| Request | - | Amendment to Special Use Permit to raze and rebuild Gasoline and Fuel Sales, originally granted by Ord. 539-80. |
| Location | - | 5820 & 5930 Hagman Road |

The staff recommends that the Toledo City Plan Commission recommend approval of SUP25-0034, a request for an Amendment to Special Use Permit for raze and rebuild of Gasoline and Fuel Sales, originally granted by Ord. 539-80, at 5820 & 5930 Hagman Road, to Toledo City Council for the following **two (2) reasons**:

SPECIAL USE PERMIT
TOLEDO CITY PLAN COMMISSION
REF: SUP25-0034
DATE: November 6, 2025
TIME: 2:00 P.M.

SHEET:
C3.0

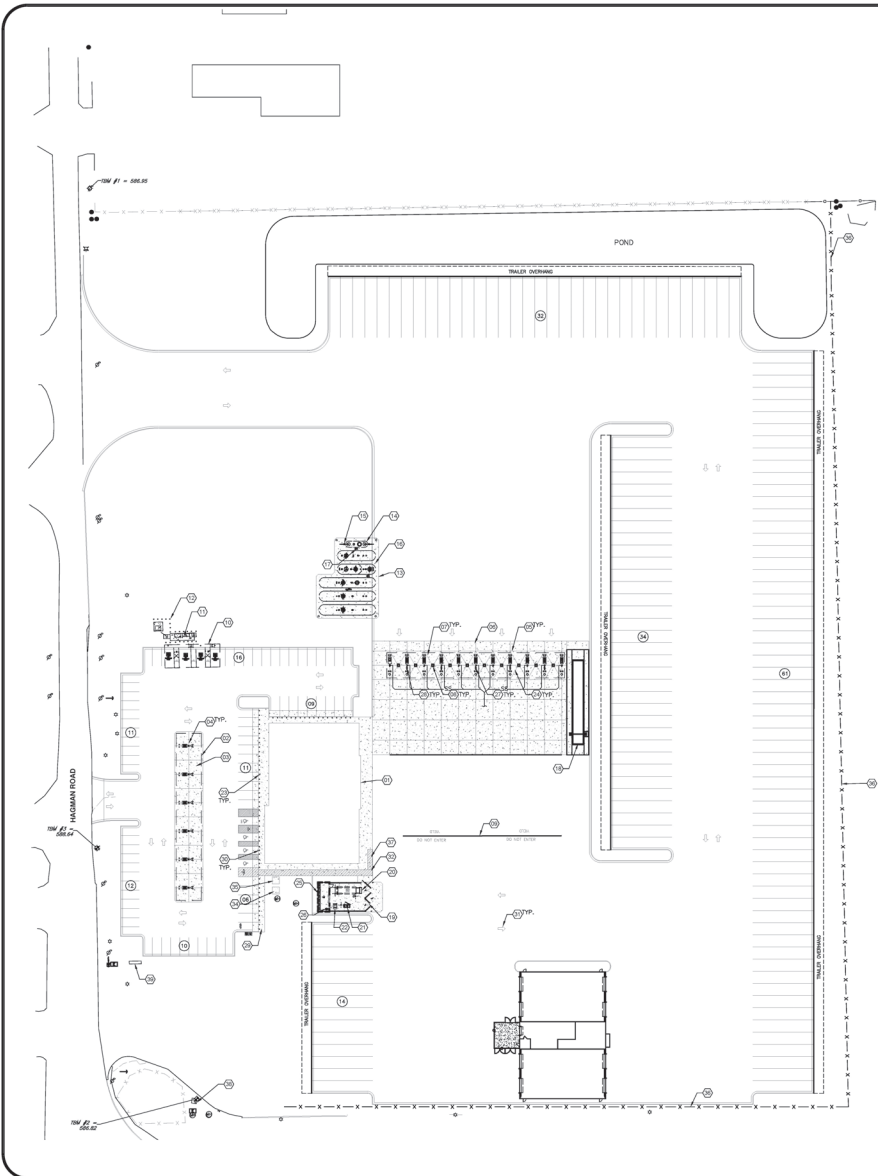
The submitted site plan does not depict the dimensions of drive aisles, maneuvering areas, off-street parking spaces, nor stacking spaces. A revised site plan that clearly defines the dimensions of such items shall be submitted and is subjected to the approval of the Division of Traffic Management.

Per TMC§1107.0901 bicycle parking shall be provided at a rate of one (1) bicycle parking slot per ten (10) parking spaces. Based on the seventy-five (75) car parking spaces provided, eight (8) bicycle slots are required. The site plan does not depict bicycle parking, a revised site plan depicting bicycle parking shall be submitted and is listed as a condition of approval. Per TMC§1107.1700 - *Accessible Parking*, one (1) van-accessible parking space with an 8-foot aisle abutting the space, and two (2) car-accessible parking spaces with a 5-foot abutting aisle are required based on the proposed parking spaces. The proposed site plan meets this requirement as two (2) car-accessible and two (2) van-accessible spaces are provided.

Connecting walkways and pedestrian connections are required per TMC§1109.0103. At least one (1) main entrance shall face and open directly onto a five-foot (5') wide connecting walkway to the street sidewalk and parking spaces. The walkways must also be distinguished from driving surfaces if it crosses parking aisles or driveways. The proposal lacks internal pedestrian circulation. Connecting walkways to the street sidewalk and to the parking spaces east and north of the primary building shall be provided and depicted on a revised site plan as a condition of approval.

All proposed signage on site must meet the regulations in Chapter 1113 - Signs. The site plan depicts the existing nonconforming mid-rise and goal post signs along Hagman Road to remain. However, neither sign meets the current Sign Code in design or height regulations. Additionally, one (1) ground sign is permitted per frontage. Pursuant to TMC§1113.0702(B), if a site undergoes Plan Commission review, any nonconforming signage on the premises shall be brought fully into compliance with the Sign Code as a part of the review and approval process.

39. Bicycle parking slots shall be provided per TMC§1107.0304 Schedule A for the proposed gas station. Eight (8) bicycle parking slots are required. **Not depicted, bicycle parking slots shall be provided on a revised site plan.**

43. Site plans shall depict the location and dimensions of drive aisles, maneuvering areas, off-street parking spaces, and stacking spaces. **Not depicted, a revised site plan depicting such items shall be provided and is subjected to the approval of the Division of Transportation.**

45. Five-foot (5') wide connecting walkways to the street sidewalk and to the parking spaces east and north of the primary building shall be provided pursuant to TMC§1109.0103. **Not depicted, a revised site plan shall be submitted.**

SHEET:
C9.0

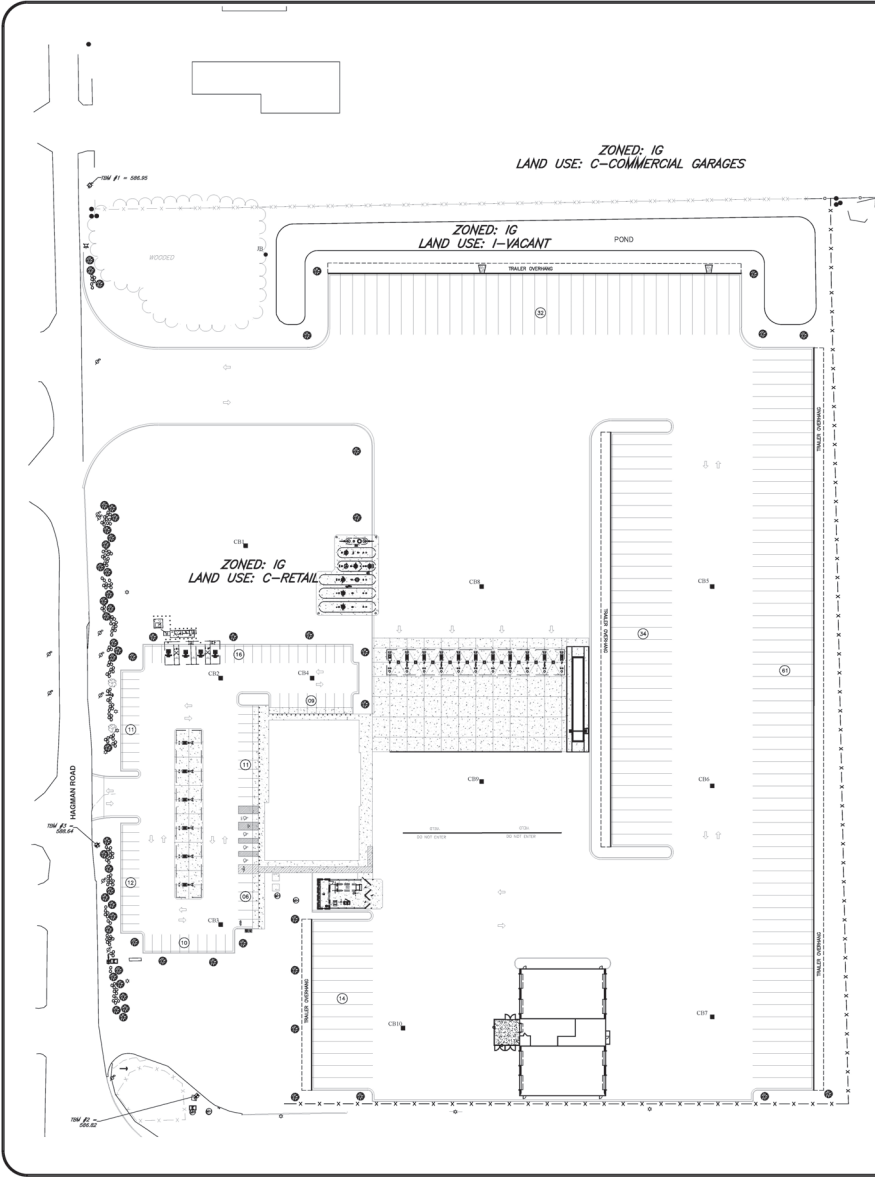
Pursuant to TMC§1108.0202, for properties over five (5) acres and/or with over 500 feet of frontage, a thirty (30') foot wide frontage greenbelt shall be provided. The frontage greenbelt shall include one (1) tree for every thirty (30) feet of lot frontage or fraction thereof. Since the parking lot is proposed in the front of the property per TMC§1108.0202(B)(2), the frontage greenbelt shall include a solid evergreen hedge planting to screen the parking lot so that no headlight of any vehicles can be seen from the public street. The site abuts a ditch along Alexis Road which is greater than thirty (30') feet in width and has numerous trees. The frontage greenbelt requirements shall be applied along Hagman Road; a minimum of thirty (30) trees shall be provided in the greenbelt. Frontage greenbelt number of plantings is acceptable as depicted on the landscape plan; thirty-two (32) trees and solid wall of shrubs are proposed. However, the width of the frontage greenbelt appears to be less than thirty (30') feet. A revised landscape plan depicting the width of the frontage greenbelt at a minimum of thirty (30') feet with the required number of plantings shall be submitted and is listed as a condition of approval.

Along the eastern property line abutting the General Industrial zoned District, a Type B landscape buffer shall be provided per TMC§1108.0203. A Type B landscape buffer shall be a minimum width of ten (10') feet and consist of four (4) canopy trees and fifteen (15) shrubs per one-hundred (100') linear feet. A fence, wall, or berm six-feet (6') to eight-feet (8') in height may substitute for shrub requirements. The submitted landscape plan does not depict landscaping along the eastern property line. A revised landscape plan depicting a Type B landscape buffer in this area shall be submitted and is listed as a condition of approval.

Interior landscaping for parking lots is required per TMC§1108.0204 at a rate of two (2) canopy trees and six (6) shrubs for each ten (10) parking spaces within the parking lot. With two-hundred and sixteen (216) total parking spaces proposed, forty-four (44) canopy trees and one-hundred thirty (130) shrubs are required. The total interior parking lot landscaping required is twenty (20) square-feet per parking and stacking space. Landscape areas within the parking area must be peninsular or island types and must be constructed with six-inch (6") by eighteen-inch (18") concrete curbing. Landscaped terminal islands must be provided at the end of each parking row and all parking spaces must be within one-hundred (100') linear feet of a landscaped area. The landscape plan depicts twenty-four (24) trees within the interior parking lot landscaping. The submitted landscape plan does not comply with these requirements. Landscape islands shall be provided at the ends of all parking rows, all parking spaces shall be within one-hundred (100') linear feet of a landscape area, and the required number of plantings for interior parking lot landscaping shall be provided and depicted on a revised landscape plan and is listed as a condition of approval.

- b. A Type B landscape buffer with a minimum width of ten (10') feet consisting of four (4) canopy trees and fifteen (15) shrubs per one-hundred (100') linear feet shall be provided along the eastern property line per TMC§1108.0203. A fence, wall, or berm six-feet (6') to eight-feet (8') in height may substitute for shrub requirements. **Not depicted, a revised landscape plan depicting a Type B landscape buffer along the eastern property line shall be provided.**

- d. Per TMC§1108.0204 interior parking lot landscaping is required at a rate of two (2) canopy trees and six (6) shrubs for each ten (10) parking spaces within the parking lot. Total interior parking lot landscaping required is twenty (20) square-feet per parking and stacking space. **Not acceptable as depicted, a revised landscape plan shall be provided.**

- e. Landscape areas within the parking area must be peninsular or island types and must be constructed with six-inch (6") by eighteen-inch (18") concrete curbing. Landscaped terminal islands must be provided at the end of each parking row. **Not acceptable as depicted, a revised landscape plan shall be provided.**

- f. All parking spaces must be within one-hundred (100') linear feet of a landscaped area. **Not acceptable as depicted, a revised landscape plan shall be provided.**

- l. The location, number, height, diameter and species of any materials to be planted and maintained, as well as the location and number of any existing trees to be preserved. **Not acceptable as depicted. The species and size of trees to be preserved shall be provided.**
